U.S. Geological Survey

May 6, 2010

Subject: USGS responses to issues raised by the Technical Memorandum, "Review and reevaluation of Skagit River 1921 flood peak discharge."

The following text summarizes the USGS responses to specific issues raised by the Technical Memorandum, "Review and reevaluation of Skagit River 1921 flood peak discharge," that was distributed at our March 17 meeting. (*Responses from the Cities of Burlington and Mount Vernon shown in italicized blue font*)

Figure 4. High-water marks (HWMs), flattest- and steepest-sloped water-surface profiles, and a HEC-RAS water-surface profile near cross sections XS1, XS2, and XS3, at Skagit River near Concrete, Washington.

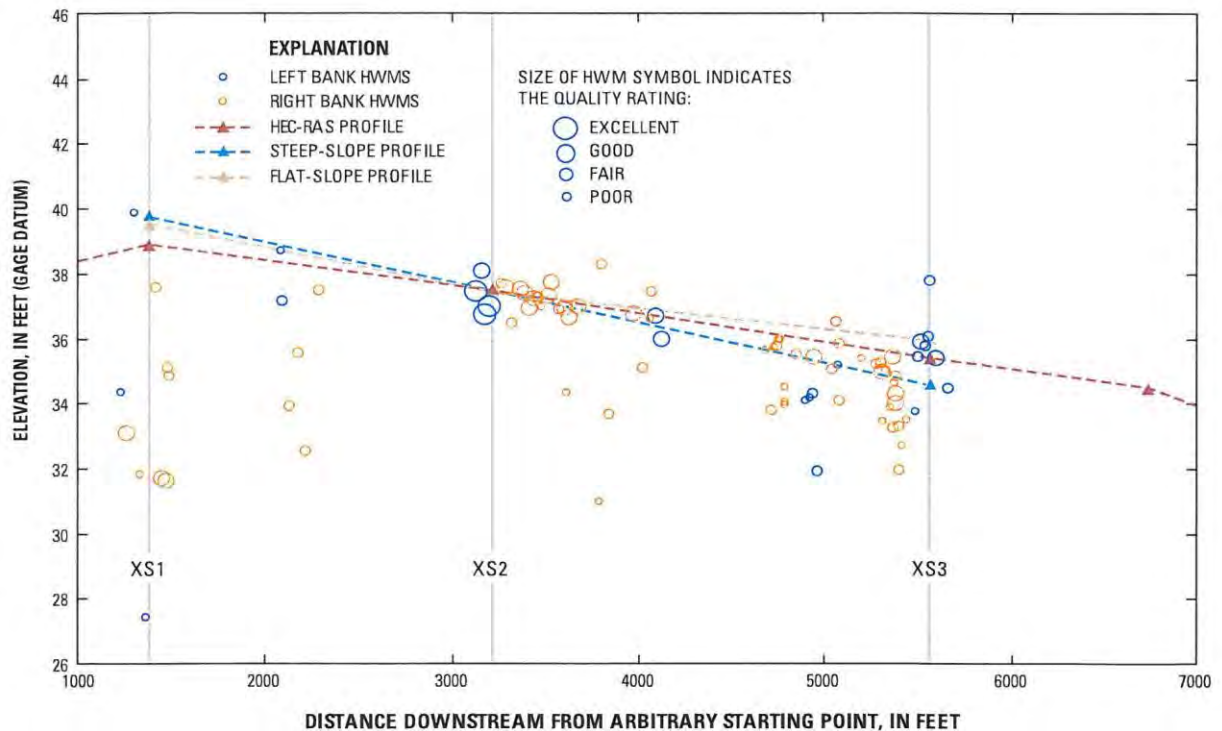
Cities' Comment (continued): The data in Fig. 4 below was collected by the USGS in the summer of 2004, following the flood of record in October 2003. The high water marks in the vicinity of cross section XS-2 are well clustered. However, the range of high water marks collected by the USGS in the vicinity of XS-3 indicate that gathering high water marks in this area was a more difficult task than at XS-2. And, in the case of XS-1, it is clear the difficulty of gathering accurate high water marks is very challenging. Note that right bank marks rated "good" are 5-8 feet below the expected water surface elevation. Two left bank marks, both rated "poor," are over 5 feet different. But the marks rated "good" at XS-3 support a flatter slope profile between XS-1 and XS-2 than that utilized by the USGS.

Figure 5. High-water marks (HWMs), cross sections (XS), and water-surface profile from the peak flow of November 27, 1949 on the Skagit River about 3,000–5,000 feet downstream of the streamflow-gaging station, Skagit River near Concrete, Washington (station No. 12194000).

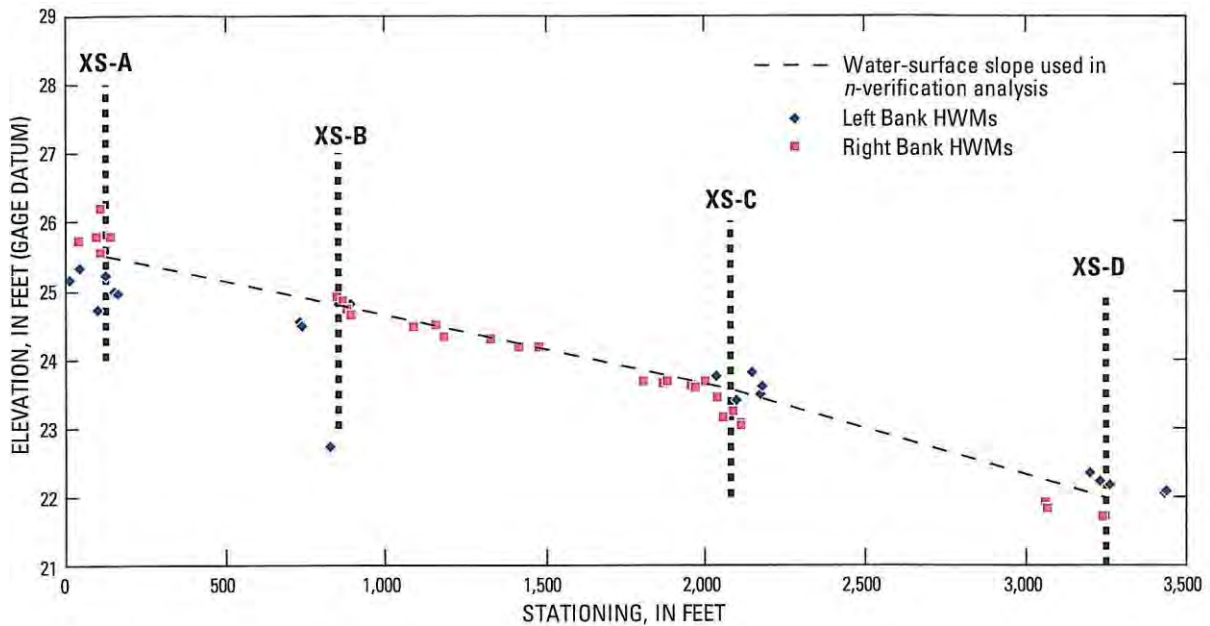
Similarly, USGS, in its 2007 report, used high water mark information gathered below the Dalles reach following the flood of 1949. See Fig. 5 below. For reference, cross section "A" of the 1949 study is about 300 feet downstream of Stewart's XS1 cross section; cross section "D" of this study is about 700 feet upstream of Stewart's XS3 cross section (near the cableway). High water marks gathered by the USGS following the 1949 flood (peak discharge in this area 154,000 cfs) are shown on the next page in Figure 5 of the 2007 USGS report on the following page:

Cities' Comment (continued): As can be seen from the figure above, the 1949 data supports a flatter slope in the upstream reach, and a steeper slope in the downstream reach. In summary, we do not concur with the USGS methodology and do not concur that the information provided by the USGS in support of its slope-area calculations, particularly using the 2006 downstream high water marks and then extending the hydraulic grade line obtained from the downstream data, through the entire upstream reach. Stewart's work should be given deference unless it can be demonstrated through newer methodologies or clearly identified inconsistencies that Stewart's data should be modified. USGS has not done so.

Skagit County Crest Stage Gage #10. Note the Dalles bridge 200 feet downstream. The current USGS gage is on the right bank just upstream of the bridge.

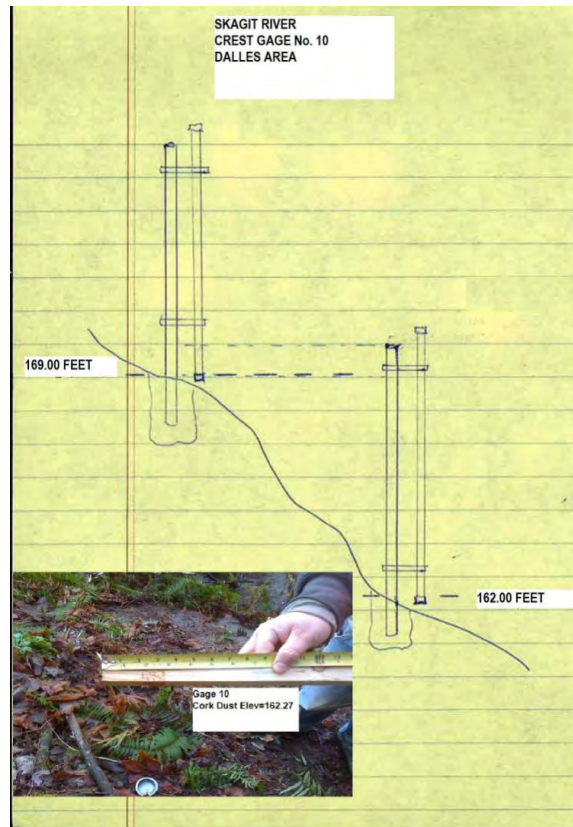
Notwithstanding the discussion about the exact location of the Upper Dalles gage with respect to the existing gage, recent new data collected by Skagit County strongly supports our assertion that these high water marks should have been adjusted for the head loss that is occurring and did occur in 1921 in this 300-foot reach. Pursuant to suggestions by the USGS to obtain head loss data through the Dalles gorge, Skagit County in November 2010 installed several

crest stage gages upstream and downstream of the current USGS gage location. As it happened, a minor Skagit flood occurred on December 12, 2010, triggering a reading on one of the crest stage gages 200 feet upstream from the current USGS gage.³ The USGS stage elevation for this minor flood, with a discharge of 81,900 cfs at the Concrete gage, was 161.22 feet NGVD 29. The crest stage gage reading 200 feet upstream was 162.27 feet, for a difference of **1.05 feet** in a 200-foot distance. This data strongly infers an estimate of as much as a 2-foot drop between Stewart's Upper Dalles gage, located 300 feet upstream of the current USGS gage for the 1921 flood is reasonable for a flood discharge in the neighborhood of 170,000 cfs.

Skagit County Crest Stage Gage #10. Note the Dalles bridge 200 feet downstream. The current USGS gage is on the right bank just upstream of the bridge.

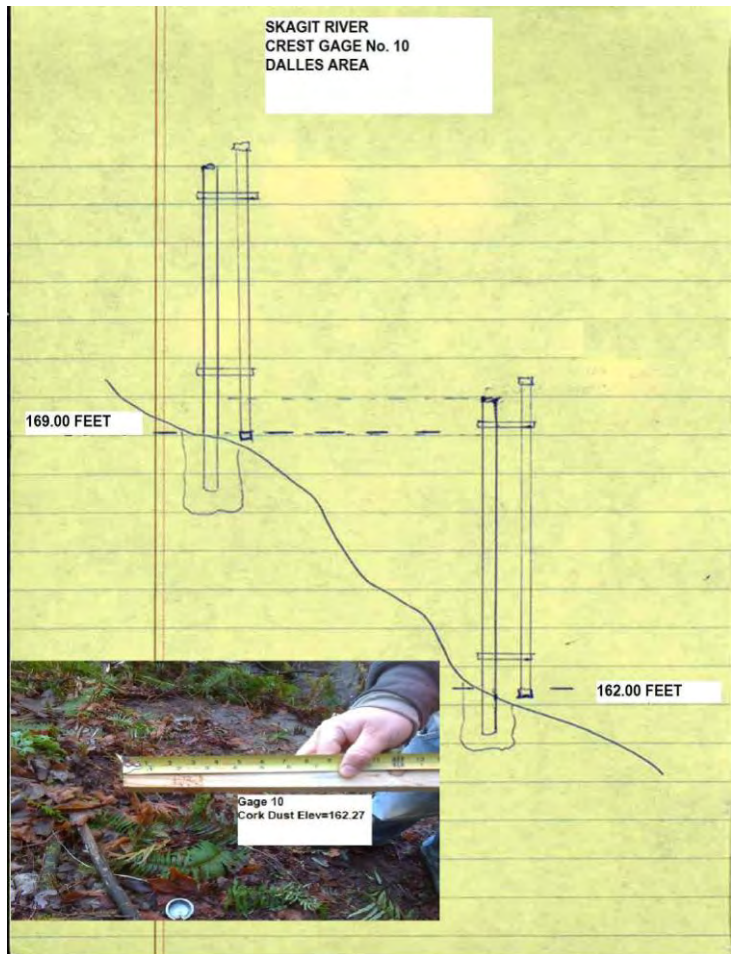
Cities' Comment: *This information is inconsistent with recently gathered (December 2010) peak stage data 200 feet upstream of the current gage by Skagit County. The location of Stewart's Upper Dalles Gage was actually 300 feet upstream of the location of today's USGS station, (see PI Engineering, March 2011, section 2.3.2) At issue is the amount of head loss to assign to high water marks gathered in the vicinity of the Upper Dalles gage that are (or were) transferred to the current gage location, 300 feet downstream. Stewart, in 1922 and early 1923, and later a survey crew from Skagit County, surveyed 1921 high water marks at the Upper Dalles Gage, and these high water marks were later transferred directly to the*

current gage location without any adjustment for head loss through this gorge, which is significant and could easily amount to 1.5 – 2 feet in a flood of the magnitude of 1921. Recent new data collected by Skagit County (December 2010) strongly supports our assertion that these high water marks should have been adjusted for the head loss that is occurring and did occur in 1921 in this 300-foot reach. Pursuant to suggestions by the USGS to obtain head loss data through the Dalles gorge, Skagit County in November 2010 installed several crest stage gages upstream and downstream of the current USGS gage location. As it happened, a minor Skagit River flood occurred on December 12, 2010, triggering a reading on one of the crest stage gages 200 feet upstream from the current USGS gage. The USGS stage elevation for this minor flood, with a discharge of 81,900 cfs at the Concrete gage, was 161.22 feet NGVD 29. The crest stage gage reading 200 feet upstream was 162.27 feet, for a difference of **1.05 feet in a 200-foot distance**. This data strongly infers an estimate of as much as a 2-foot drop between Stewart's Upper Dalles gage, located 300 feet upstream of the current USGS gage for the 1921 flood is reasonable for a flood discharge in the neighborhood of 170,000 cfs. Nevertheless, PI Engineering's estimate of the head loss is only 1.2 feet – clearly conservative in light of this new data.

Rereading these notes, the HWM at the upper gage was at an elevation of 27.468 feet (gage datum) not 27.714 feet. It was located at the upper section of the upper gage not the current gage. The recorded gage height for the February 27, 1932 peak was 27.30 feet (gage datum) at the current gage. Thus, the difference of 0.17 feet would equate to a slope of 0.00085 computed over a distance of 200 feet and not 0.0012 as previously stated.
